RE: Revised Remedial Design
4191 First Street, Pleasanton, California
Fuel Leak Case No.: RO0000361

**Revised Remedial Design
Response to ACEH Comments**

Unocal Site 7376
4191 First Street
Pleasanton California
Alameda County Fuel Leak Case No. RO0000361

SITE MAP WITH PROPOSED SHALLOW WELL AND TRENCH LOCATIONS

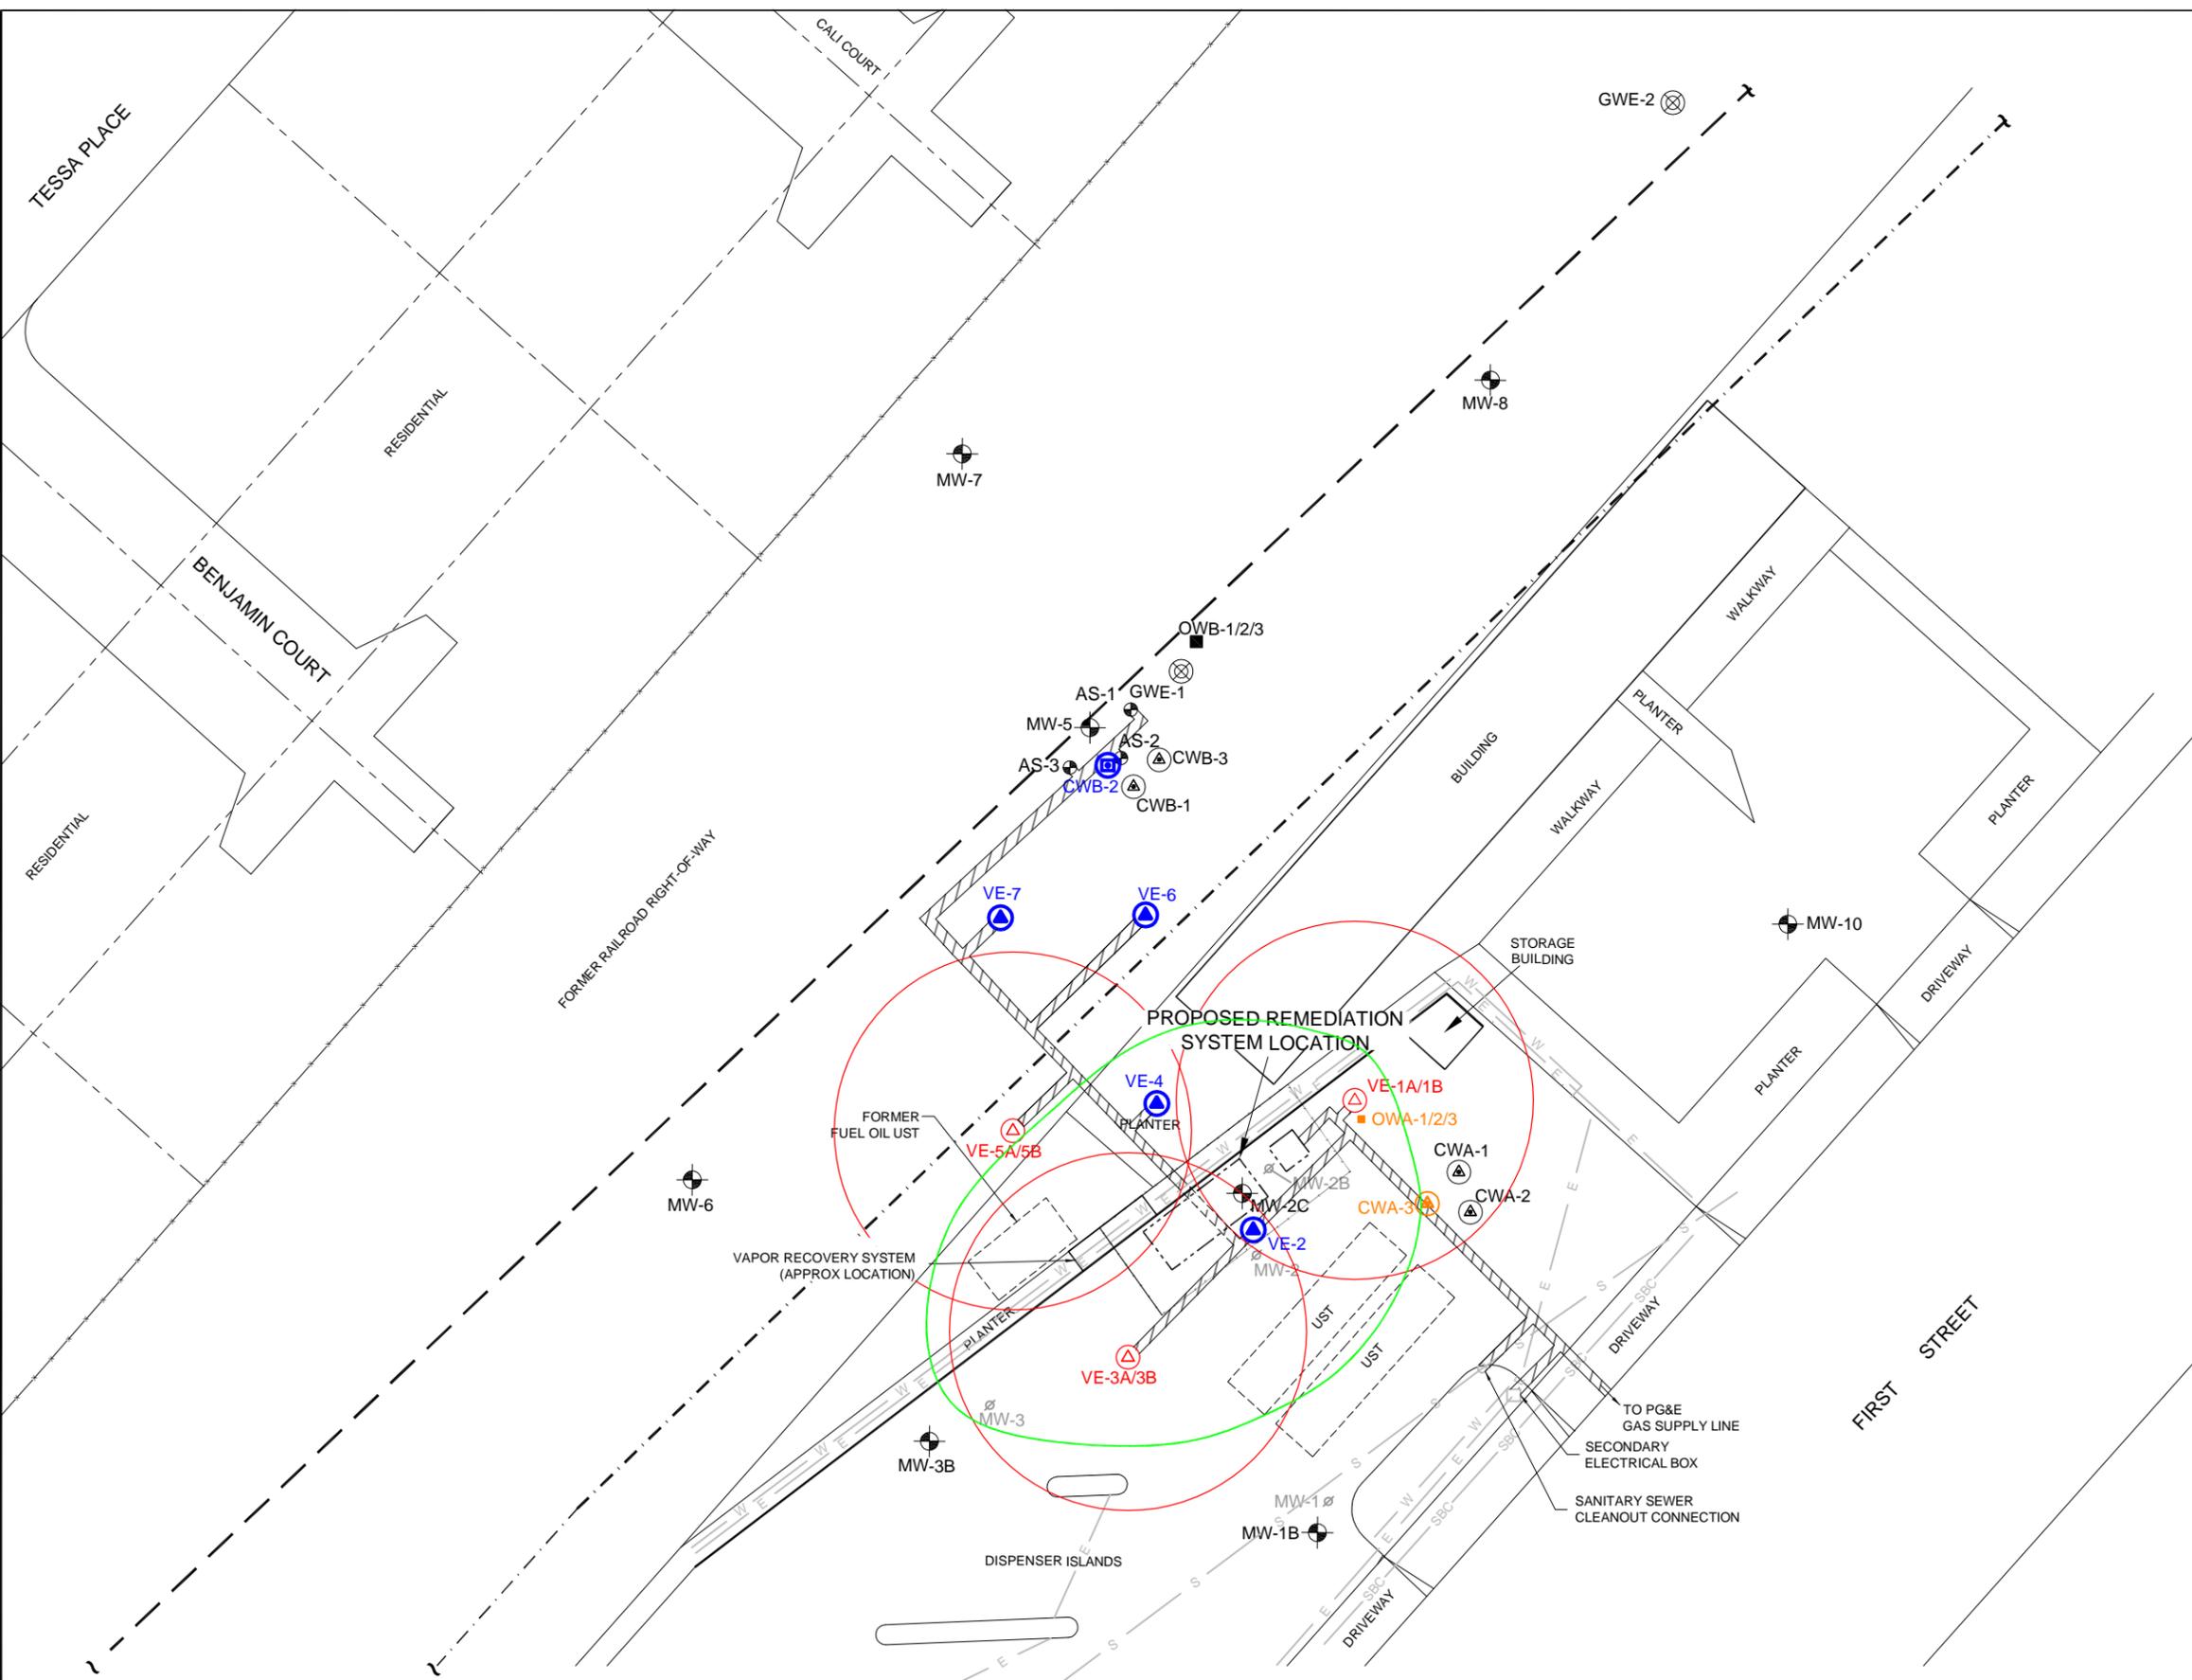
1. ***Radius of Influence and Number of SVE Wells. The Revised Remedial Design indicates that the radius of influence (ROI) was not calculated correctly and proposes the use of higher ROI values for design. As a result, the Revised Design incorporates a significantly reduced number of extraction wells for the soil vapor extraction (SVE) system. Given that the site stratigraphy appears to be complex with possible horizontal and vertical discontinuities, it is not clear that the proposed well design is conservative enough to ensure that the system will be able to adequately treat the targeted area and vertical intervals. We request that you review the site-specific conditions and re-consider the design in light of the site heterogeneity. Upon review, if you believe that the proposed design is adequate, please include a sufficient number of vapor monitoring points in the design to allow assessment of the system performance during SVE operations.***

- 2. Air Sparging and Removal of Groundwater Extraction. The proposed incorporation of air sparging in lieu of groundwater extraction is acceptable. In the Revised Remedial Design requested below, please include the three proposed air sparging wells into the remedial system. Groundwater extraction may be used as a contingency.**

- 3. *Compound Location and Abatement Equipment. In the Revised Remedial Design requested below, please include a new location for the system compound. The size of the abatement equipment may be modified as necessary to match the anticipated treatment volumes.***

After in-depth review of cross-sections developed from site boring logs, the conservative ROI presented within ARCADIS' "Revised Remedial Design" will deliver effective flow coverage despite site heterogeneity. The revised design ROI for the shallower zone (sands/gravels) and deeper zone (finer grained soil) is 30 feet and 20 feet, respectively. These conservative ROI estimates are based on the smallest ROI observed during previous pilot testing efforts to ensure adequate coverage at the site. Additionally, well construction and well layout details were designed to address interpreted lithologic heterogeneities. The majority of clay lenses or pockets causing discontinuity within the formation exist on-site. Dual-nested shallow and deep SVE wells are proposed onsite to address possible decreased influence across vertical and horizontal gradients within the formation. Screen intervals will be also open to variation in the field to compensate for any unanticipated impermeable layers observed during well installation.

Onsite monitoring wells OWA-1 and CWA-3 will be used to monitor shallow induced vacuum gradients (Figure 1A). In addition, proposed vapor extraction wells VE-1A, VE-2, and VE-3 will be used to monitor shallow induced vacuum gradients when not in operation. Onsite wells OWA-2, OWA-3, CWA-1, and CWA-2 will be used to monitor deep induced vacuum gradients.

The three proposed offsite air sparge well (AS-1, AS-2, and AS-3) locations are shown on Figures 1A and 1B. The remediation compound was designed to allow space for contingency groundwater extraction system components. A sewer cleanout connection will be made during trenching activities to allow

The new proposed remediation compound location is shown on Figures 1A and 1B. The new location selection process included evaluation of accessibility, minimal disturbance to service station operations, distance from the nearby office building, and structural stability of existing topographic conditions.
